**FILE:** BRMLB-9004(8) Cobb  
P. I. No.: 752630  
Canton Road & RR Bridge over U.S. 41/Cobb Parkway

**SUBJECT:** IMPLEMENTATION OF VALUE ENGINEERING STUDY ALTERNATIVES

**SUBJECT** Value Engineering Study - Responses

#### **9. Design Consideration 4; re-align the railroad to the north of Canton Road**

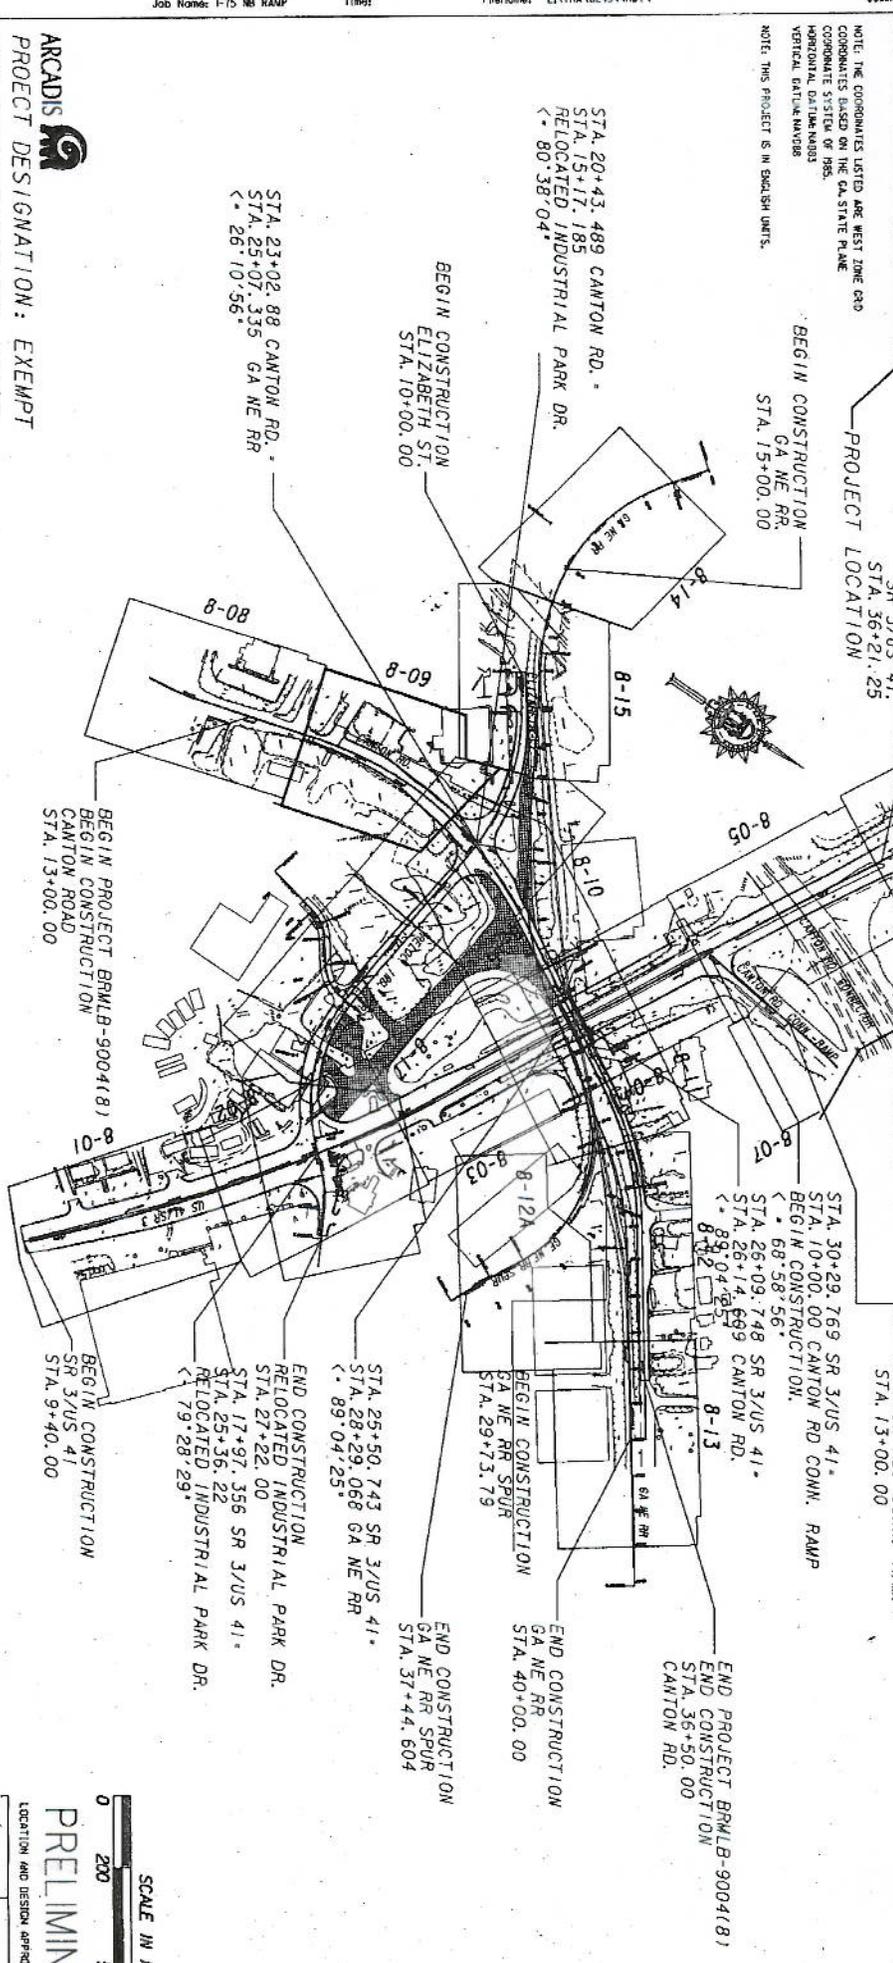
This consideration is recommended by the design team. As mentioned previously, the re-alignment of Canton Road to the south/west of the railroad was included in the submittal for approval made to GNRR on December 6, 2007. This will allow railroad operations to continue at their existing speed with lower maintenance costs by eliminating the numerous curves on the mainline alignment. This alternative will also allow both bridges to be constructed with minimal disruption to traffic on Canton Road and will have significant positive impact on Right-Of-Way for parcel 9.
